**PLANNING COMMISSION AGENDA
CITY OF PRAIRIE VILLAGE
TUESDAY, MARCH 5, 2013
INDIAN HILLS MIDDLE SCHOOL
6400 MISSION ROAD
7:00 P. M.**

**PLANNING COMMISSION MINUTES
FEBRUARY 5, 2013**

TO: Prairie Village Planning Commission
FROM: Ron Williamson, Lochner, Planning Consultant
DATE: March 5, 2013 Planning Commission Meeting

SPECIAL USE PERMIT PLAN— PHASE 1
ST. ANN CATHOLIC CHURCH
 PRAIRIE VILLAGE, JOHNSON COUNTY, KANSAS

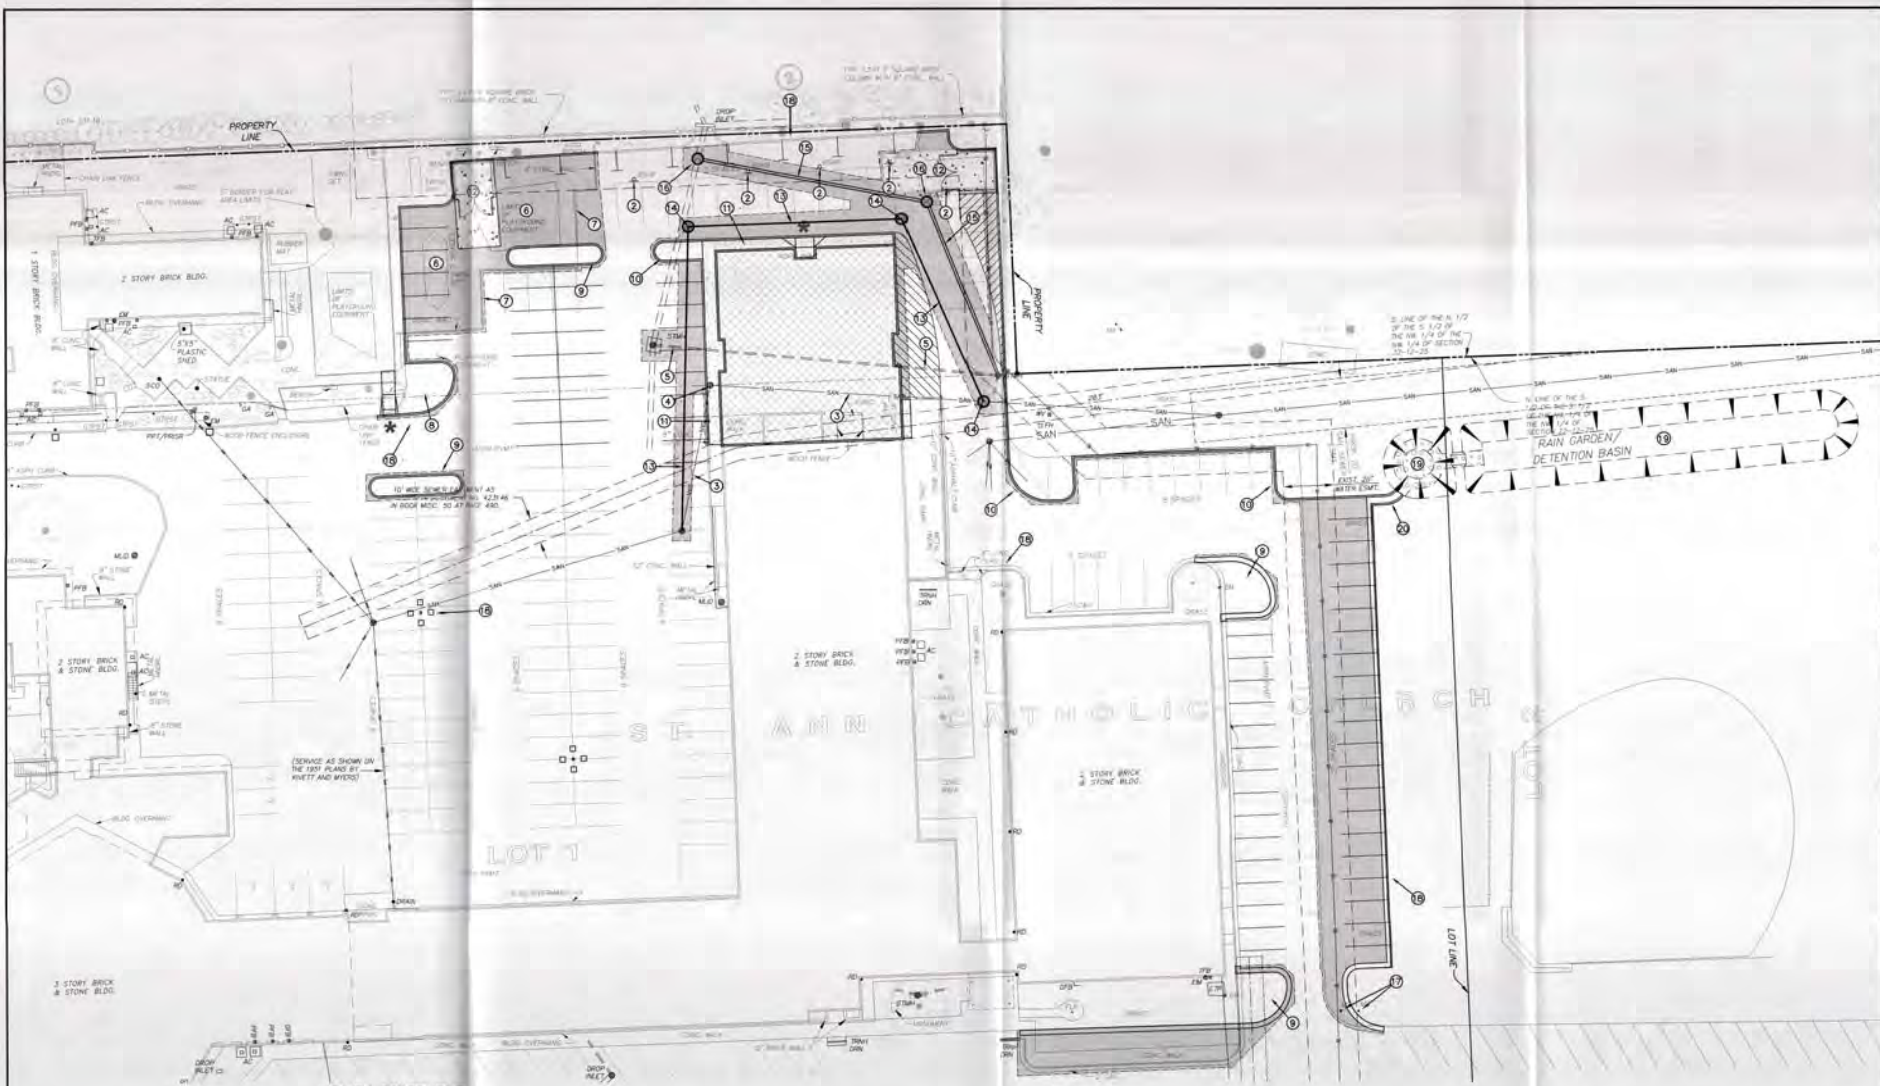
- THE REQUIRED PARKING IS 232 STALLS BASED ON THE ASSEMBLY OCCUPANCY OF THE CHURCH. A COMBINED OCCUPANCY OF THE SCHOOL, OFFICE, AND DAYCARE IS MUCH LESS. THE DRAWING HAS BEEN UPDATED TO SHOW THIS INFORMATION.

- THE DRAINAGE STUDY HAS BEEN DONE. THE REPORT WAS ATTACHED TO THE SITE PLAN APPLICATION ISSUED TO THE CITY. A COPY IS ATTACHED TO THIS LETTER FOR REFERENCE.

- THE REQUIRED TURNING RADIUS HAS BEEN ACCOMMODATED. (IT IS SHOWN ON THE SUPPLEMENTAL DRAWING ATTACHED TO THIS LETTER.)
- ALL NEW MECHANICAL UNITS WILL BE SCREENED.

- ADDITIONAL NARRATIVE HAS BEEN ADDED TO THE PHASE NOTES AS SHOWN ON THE UPDATED DRAWING.
- LANDSCAPE ISLANDS HAVE BEEN CONSIDERED. THE OWNER'S NEEDS FOR AN UNCLUMBERED PAVED AREA OUTWEIGH THE POTENTIAL APPEAL OF ISLANDS. THE PARKING LOT IN QUESTION IS INTERNAL TO THE SITE AND SCARCELY VISIBLE FROM MISSION ROAD. IT IS USED FOR HARD PLAYGROUND SURFACE FOR THE SCHOOL. THIS IS ALSO THE MOST USED PARKING AREA FOR THE CHURCH, OFFICES, SCHOOL, AND DAYCARE. ANY REDUCTION IN AVAILABLE PARKING SPACES AT THIS LOCATION WOULD BE DETRIMENTAL.

- THE NEW DRIVE IS DESIRED TO PROVIDE ADDITIONAL ACCESSIBILITY TO THE MAIN CHURCH SANCTUARY AND CHAPEL. THERE IS A GROWING ELDERLY POPULATION IN THE PARISH. WE ARE ADDRESSING ACCESSIBILITY NEEDS ON SEVERAL FRONTS: THE MAIN ACCESSIBLE ENTRANCE AND PARKING WILL BE LOCATED AT THE NEW FRONT DOOR TO THE FACILITY, WHICH IS OFF THE INTERIOR PARKING LOT. THERE IS STILL A NEED TO GET MOBILITY-CHALLENGED PEOPLE AND EQUIPMENT (FUNERAL CASKETS) DIRECTLY INTO THE SANCTUARY ON-GRADE. THE PARISHIONER SURVEY CONDUCTED BY THE OWNER SHOWED A VERY HIGH DEMAND FOR A DROP-OFF AREA AT THE SANCTUARY DOORS. THIS IS THE SHORTEST WALKING/TRAVEL DISTANCE TO THE WORSHIP SPACE. IT WILL ALSO PROVIDE BETTER ACCESS FOR EMERGENCY RESPONSE VEHICLES. THE PARKING PROVIDED IN THE FRONT IS INTENDED TO BE USED IN CONJUNCTION WITH A POTENTIAL ADORATION CHAPEL USE AFTER BUSINESS HOURS. THIS ALLOWS THE CHURCH TO CLOSE DOWN THE REST OF THE BUILDING WHILE ALLOWING A HANDFUL OF PEOPLE TO VISIT THE CHAPEL. WE ARE ADDING GREEN SPACE TO THE FRONT LAWN BY DEMOLISHING THE CURRENT OFFICE BUILDING AND LOCATING THE REPLACEMENT STRUCTURE FARTHER AWAY FROM THE ROAD. WE ARE ALSO ADDING A GREAT DEAL OF LANDSCAPING TO THE FRONT LAWN WHILE PRESERVING THE LARGEST OF THE ESTABLISHED TREES. THE FRONT LAWN WILL CONTINUE TO BE AN AESTHETICALLY PLEASING ENVIRONMENT. THIS IS IMPORTANT TO THE OWNER FOR THEIR IDENTITY TO THE COMMUNITY.

West Elevation - North Building

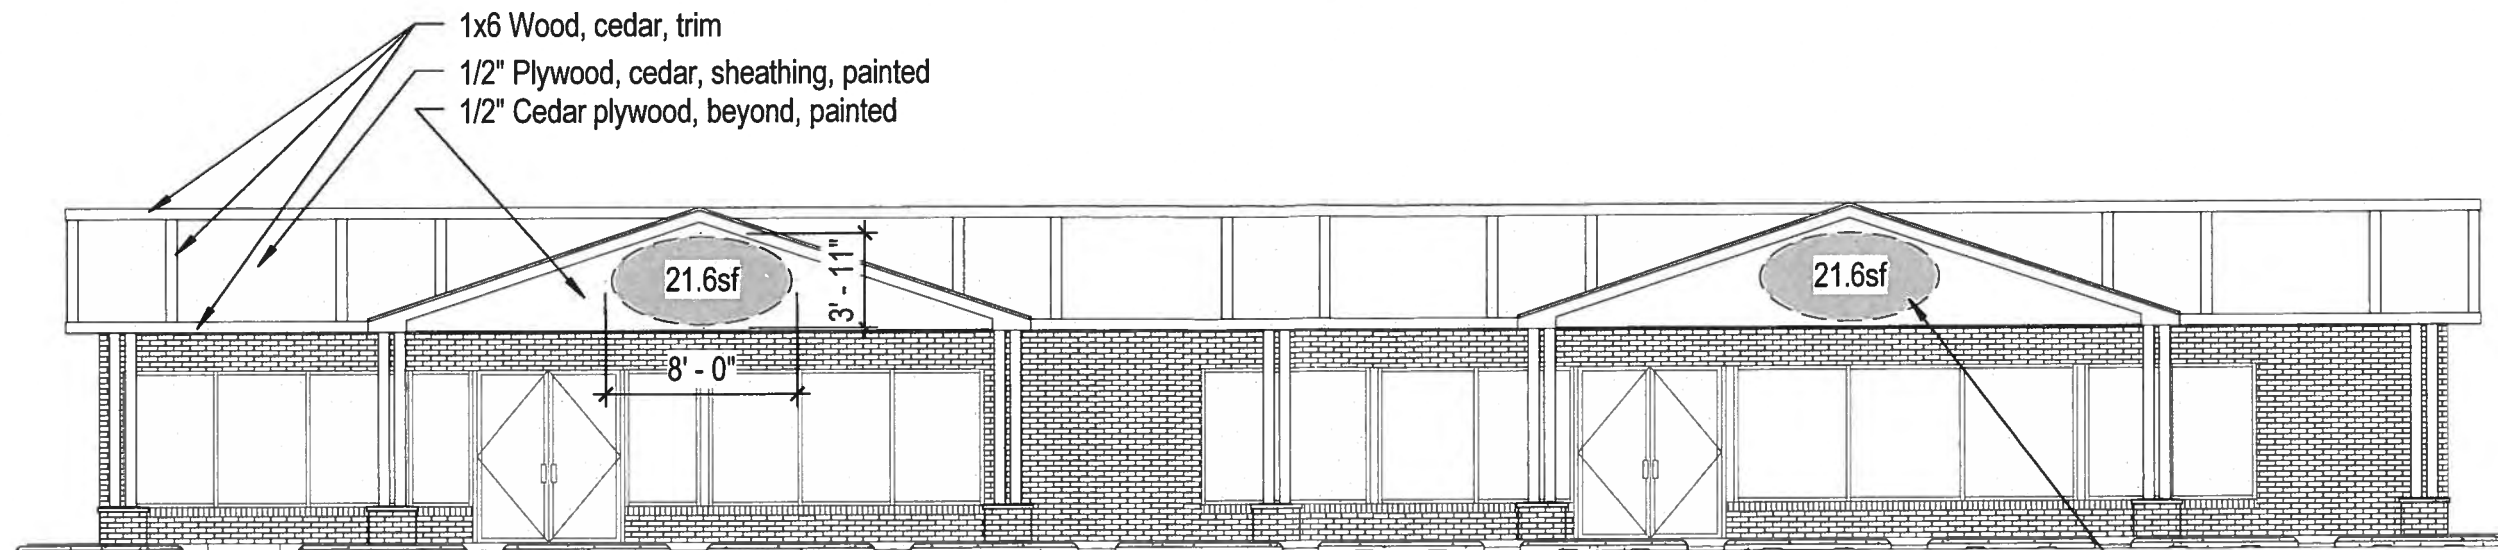
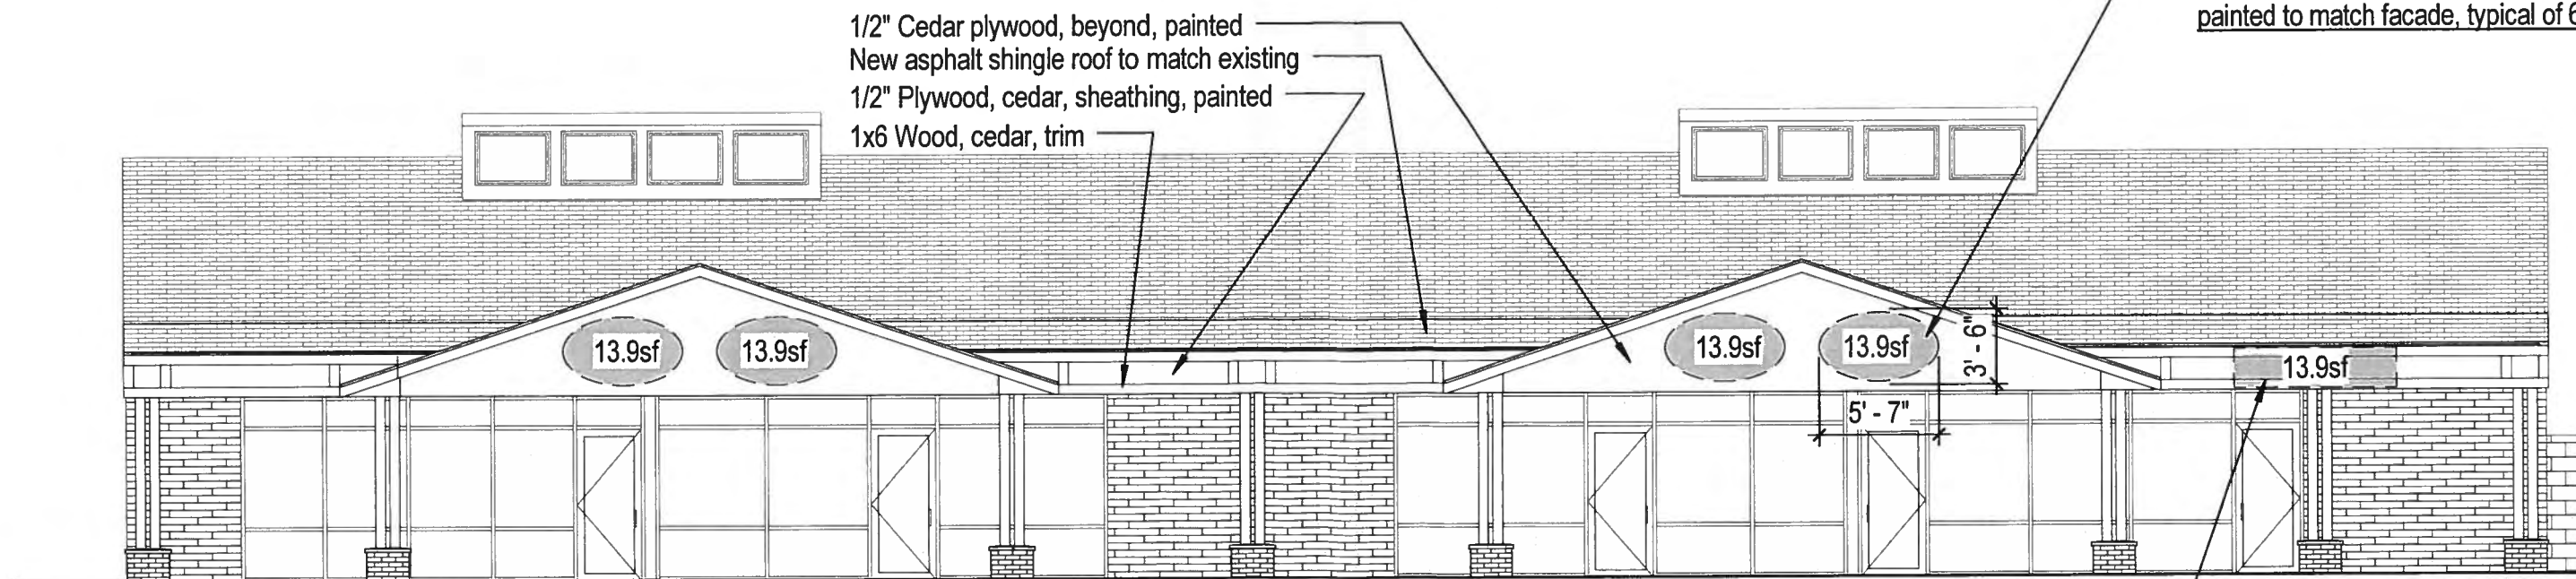
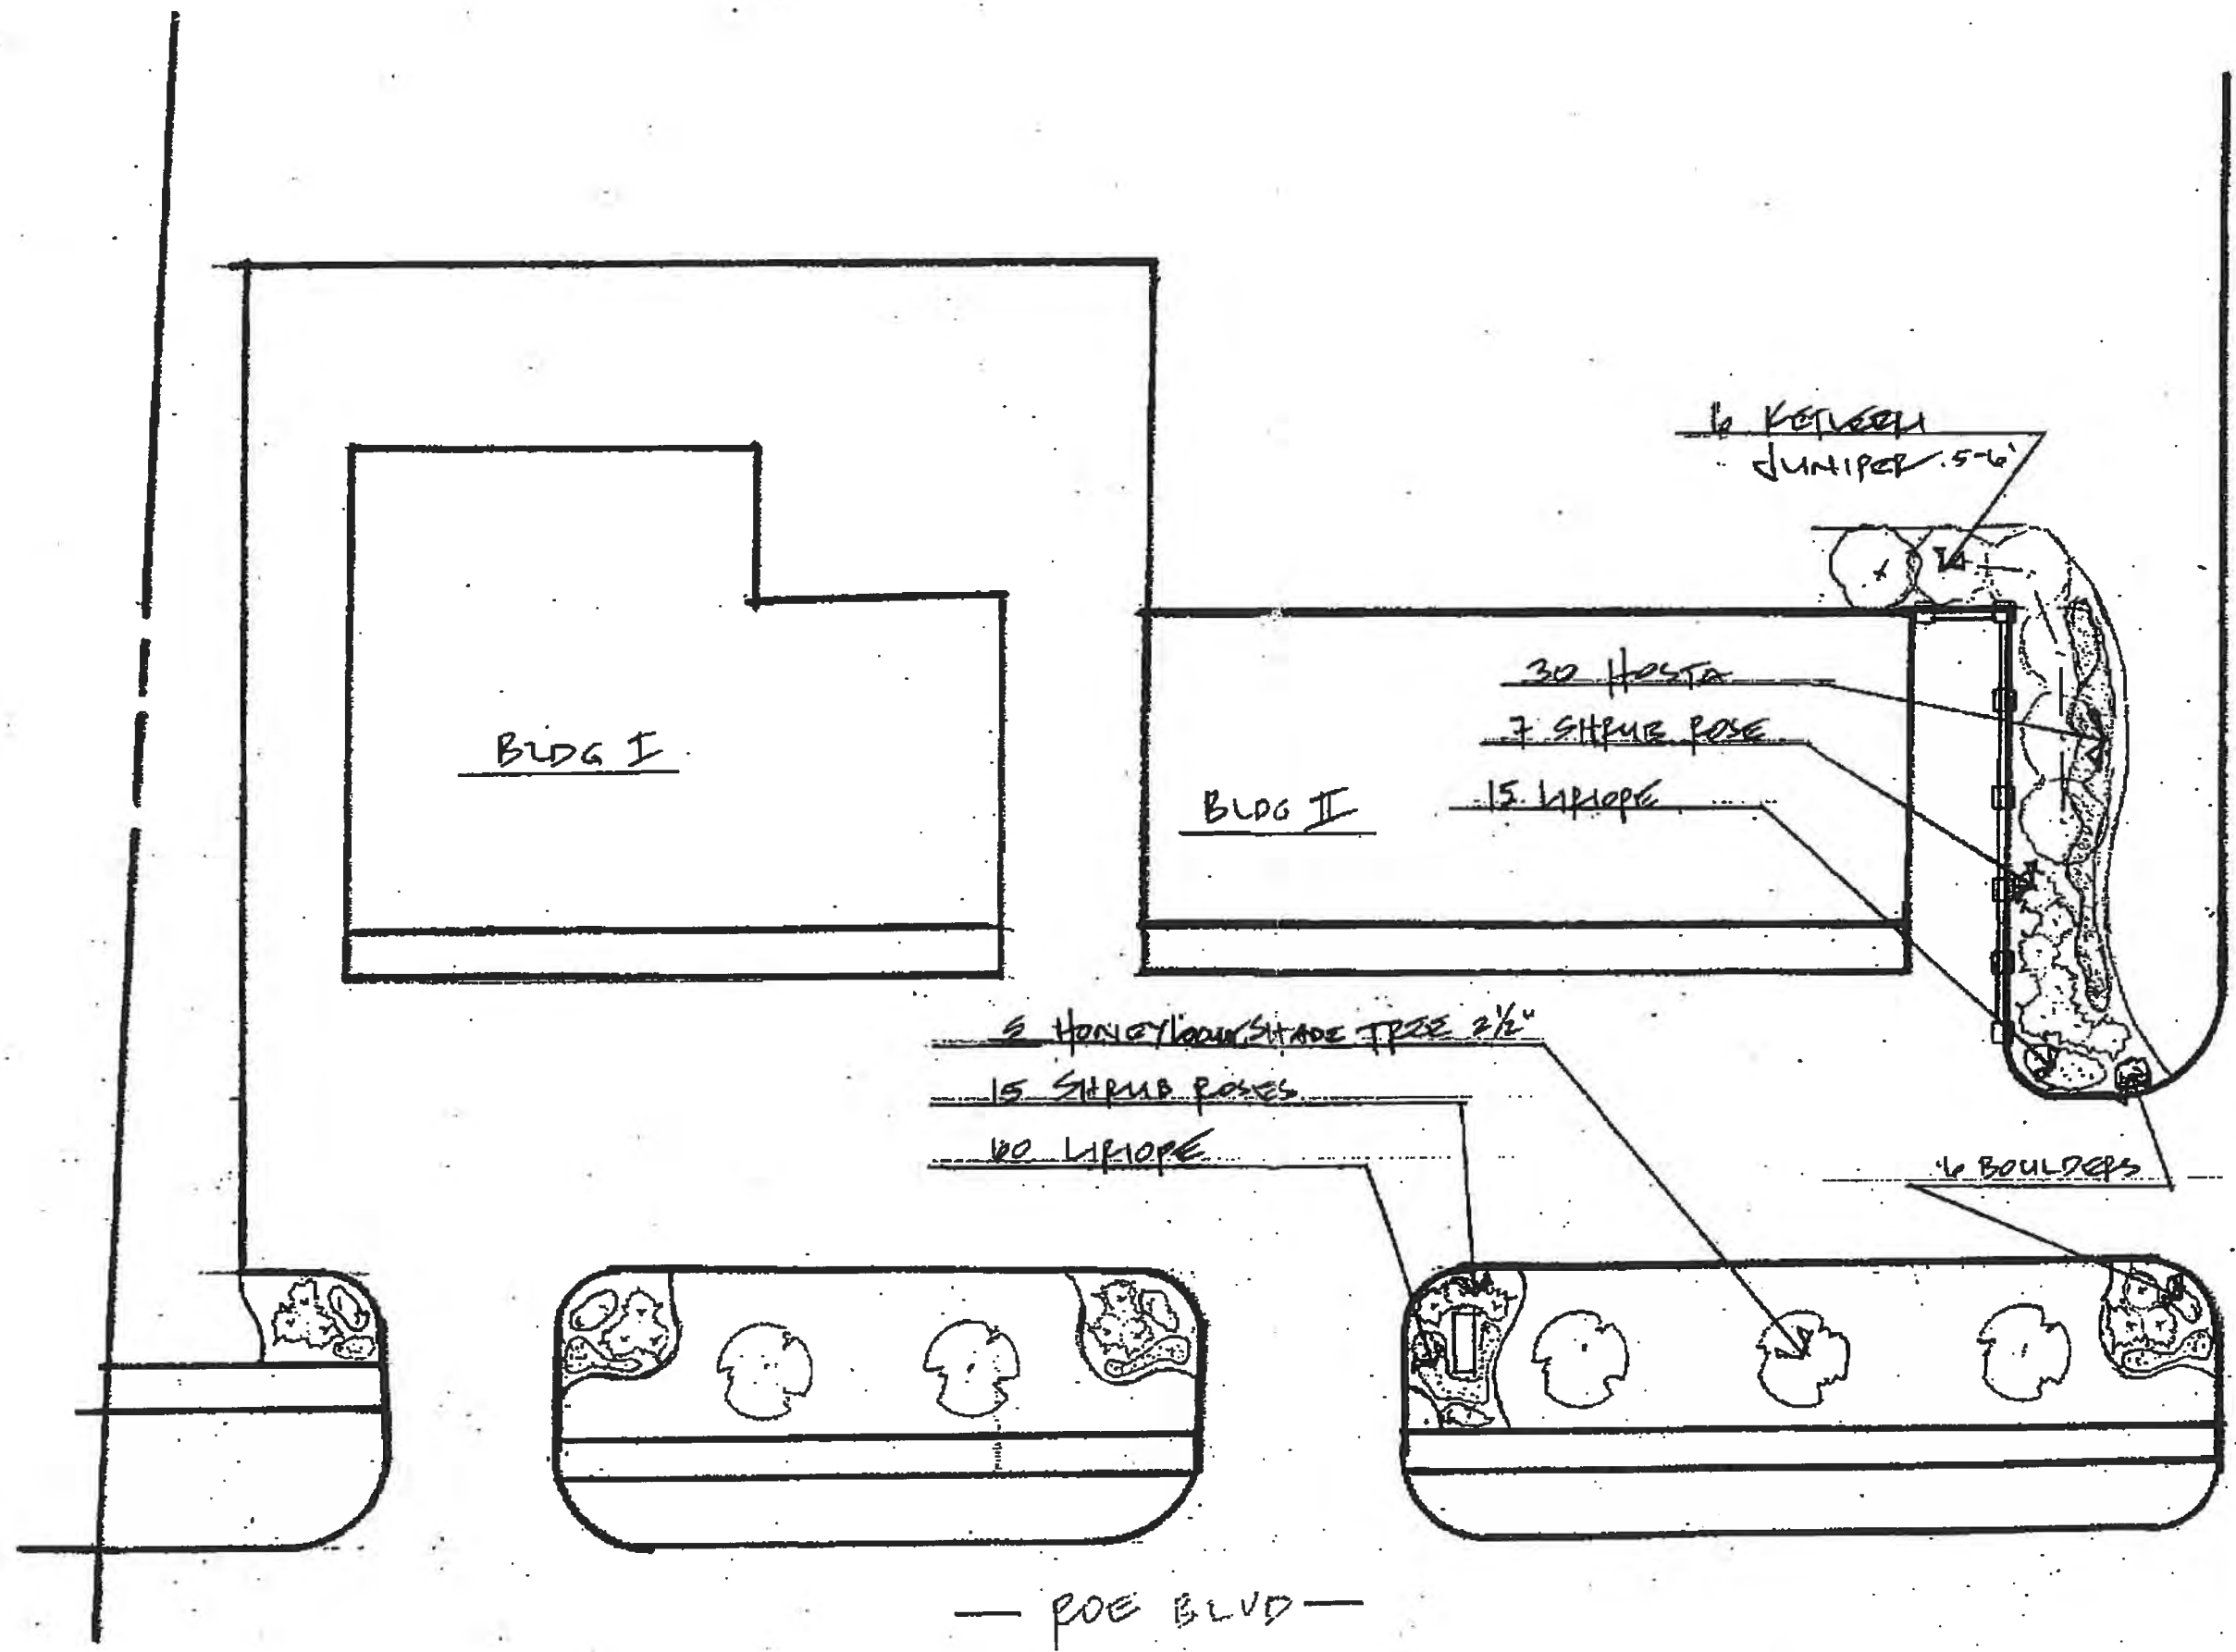
1. The title of paragraph “1. Elliptical Under Gable - Signage” should be revised to “1. Elliptical Under Gable and Band Sign - Signage”.
 2. Text needs to be added to paragraph 1.a. that “Only one sign shall be permitted per tenant and no sign shall exceed 5% of the square feet of the tenants’ facade.
 3. Add paragraph 5. Monument Sign:
 5. Monument Sign:
 - a. One monument sign shall be permitted for the two building complex.
 - b. The sign face may be changed out by City Staff approval.
 - c. If the monument sign is relocated or redesigned, it will be required to be submitted to the Planning Commission for review and approval.
 4. Remove the window dormers on the south building elevation and submit revised drawings to the City.
-
